RENESAS TECHNICAL UPDATE

Product Category	MPU/MCU		Document No.	TN-SY*-A001A/E	Rev.	1.00
Title	Restriction on S3 Series MCU		Information Category	Technical Notification		
Applicable Product	Synergy/S3 Series S3A7 R7FS3A77C3A01CFB#AA0 R7FS3A77C3A01CFP#AA0 R7FS3A77C3A01CFM#AA0		Lot No.	Reference Document	Synergy/S3 Series User's Manual: Microcontrollers	
			All lots

The following figure indicates the countermeasure using a GPT timer.

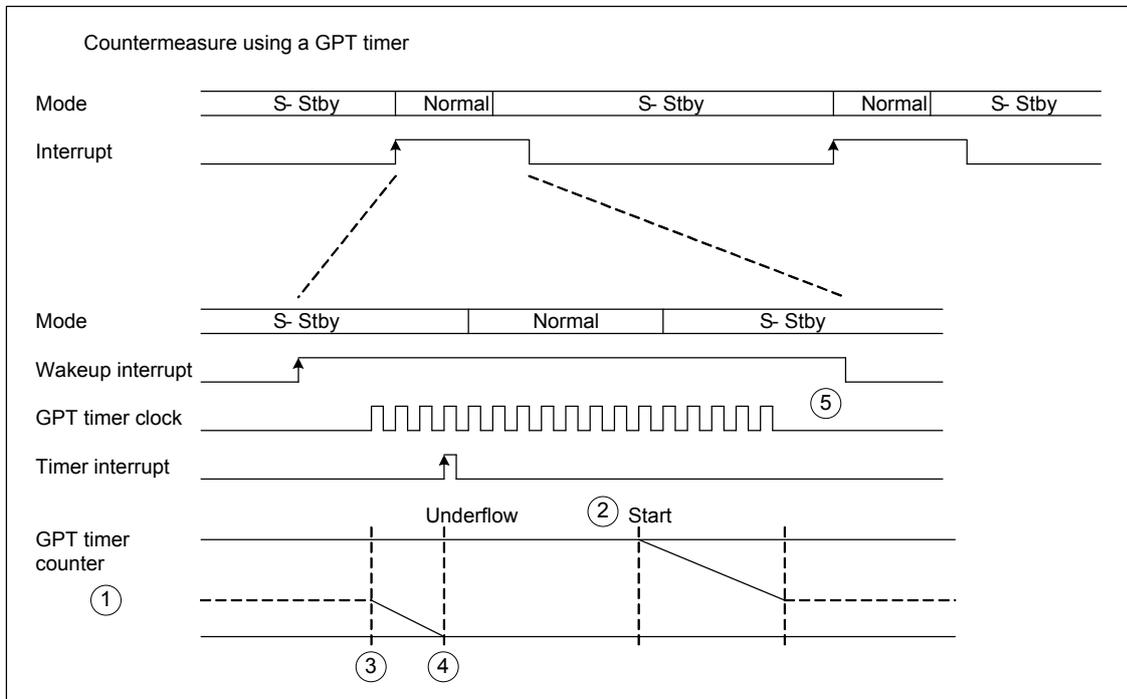
If the application cannot wait for the peripheral interrupt signal to be negated before returning to Software Standby mode, another timer can be used for the return to Normal mode. This requires additional resources: one additional GPT timer and one more interrupt vector.

1. Choose an available GPT timer and assign the interrupt vector.
2. Before execution of WFI instruction, start the GPT down counter. The GPT will start counting until the clock stops, at which time the MCU transfers to Software Standby mode.
3. When a wakeup interrupt occurs, the GPT clock source and GPT timer are activated. GPT restarts

counting from the previous value. Because wakeup interrupt takes longer to negate, it is not used to wake up the CPU.

4. When a GPT underflow occurs, the GPT interrupt wakes up the CPU to Normal mode. The interrupt handler of the GPT timer should then be stopped, and the application invokes the original wakeup interrupt handler.
5. Perform the same operation to transition to Software Standby mode again.
